1988 - 1989 Corvette: Recall Notice: Rear Wheel Tie Rod

Bulletin No: 89C17

Subject: PRODUCT SAFETY CAMPAIGN 89C17
REAR WHEEL TIE ROD

Model and Year: 1988-89 CHEVROLET CORVETTE

FIGURE 1

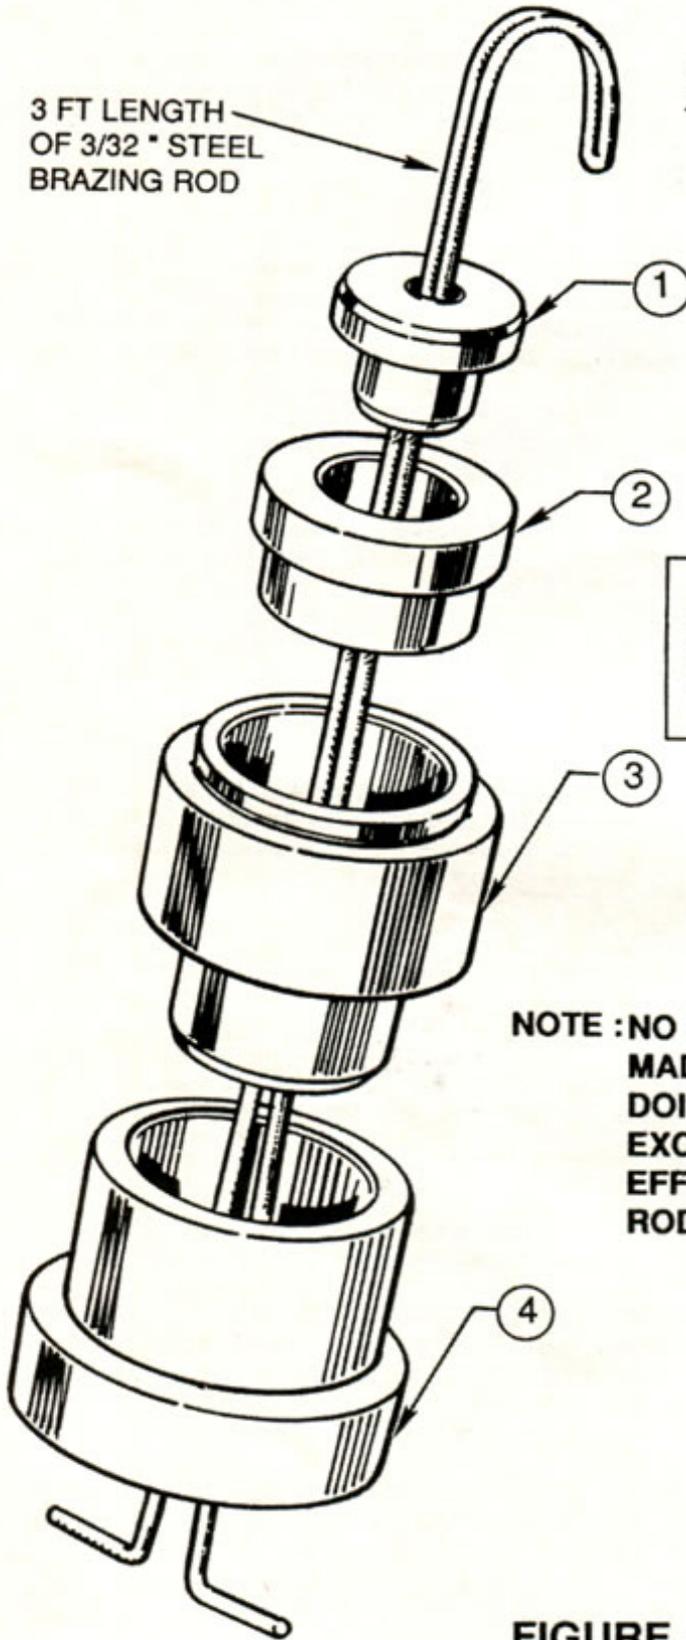
1. Fabricate/Assemble weight from materials indicated and as illustrated in Figure 1.
2. Raise Vehicle.
3. Remove cotter pins, nuts and washers from both outer rear tie rod ends and disconnect from knuckle assemblies utilizing tool J-24319-01.

3 FT LENGTH
OF 3/32 " STEEL
BRAZING ROD

- ① J - 24895
- ② J - 9398 - A
- ③ J - 9481 - A
- ④ J - 26271 - A

**NOTE : NO SUBSTITUTIONS SHOULD BE
MADE FOR THE TOOLS INDICATED.
DOING SO, MAY RESULT IN AN
EXCESSIVE WEIGHT WHICH COULD
EFFECT THE ACCURACY OF TIE
ROD INSPECTION.**

FIGURE 2

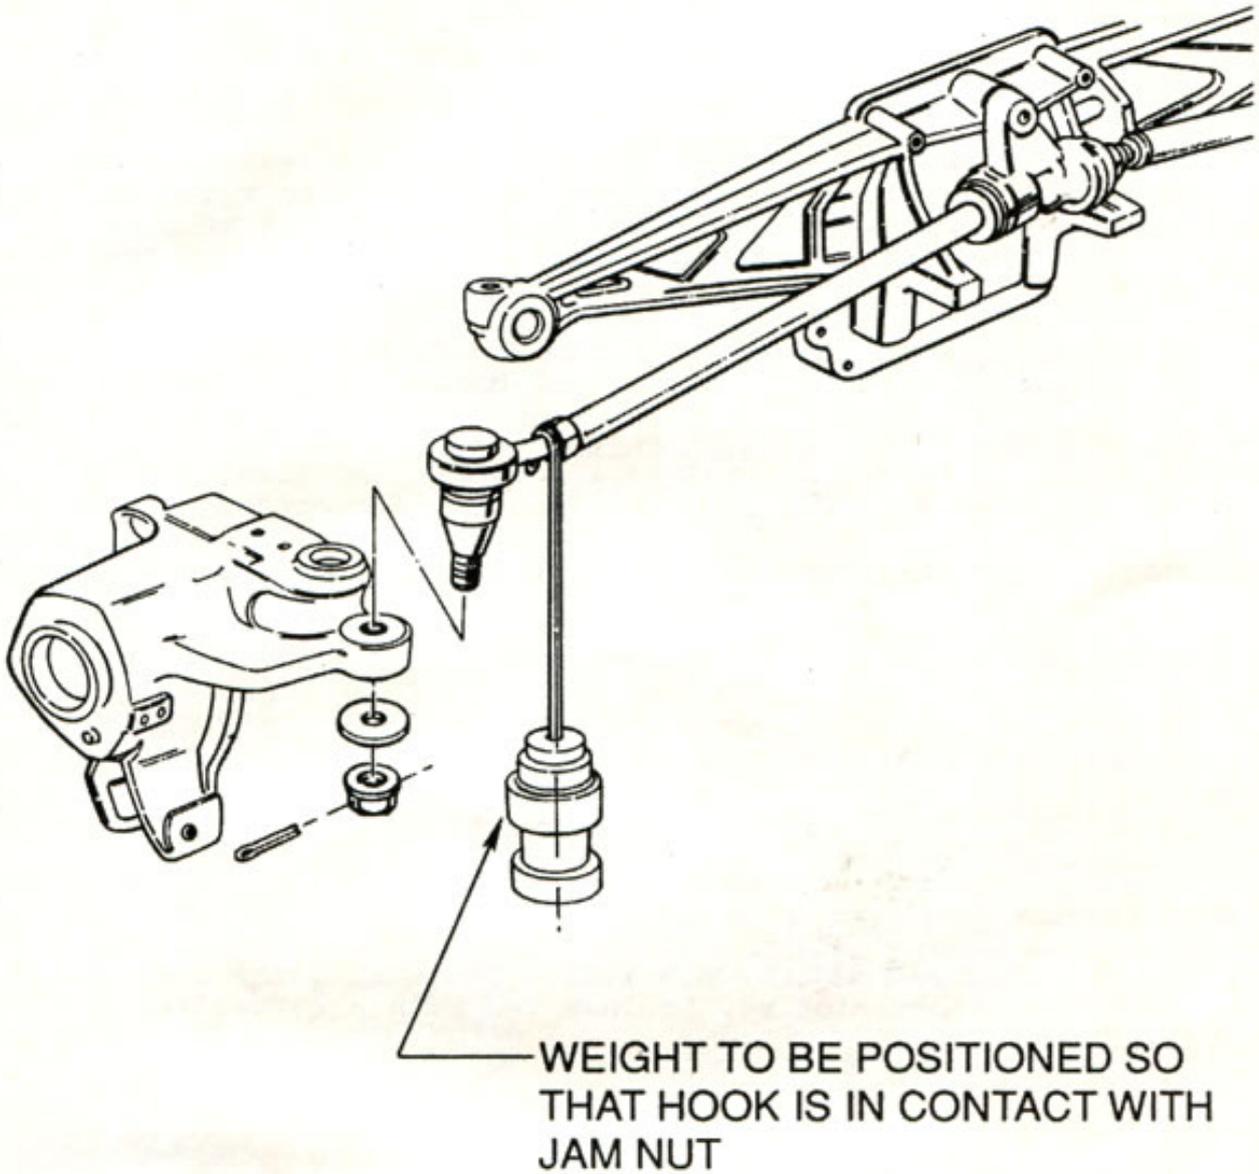
4. Raise and hold outer end of left hand tie rod linkage in its upper most position, insuring rod is not rotated while being raised. Attach weight as shown in Figure 2, release linkage and note results. Repeat procedure on right hand tie rod linkage.
5. Based on observations noted in performing step 4, select appropriate action from those noted below:
 - A. Linkage moves downward on both sides - Reconnect tie rod sockets to knuckles, install washers and nuts, torque nuts to 45 Nm (33 lbs. ft.) and install cotter pins.
 - B. Linkage on either or both sides doesn't move downward - Replace tie rod assembly, transferring existing tie rod ends to new assembly and following Section 3D in the Chevrolet Corvette Service Manual of the appropriate year.
6. Install Campaign Identification Label.

To prevent this condition from occurring, involved vehicles will be inspected to determine the amount of rocking torque on each tie rod. Tie rod assemblies above 12Nm rocking torque on either side will be replaced.
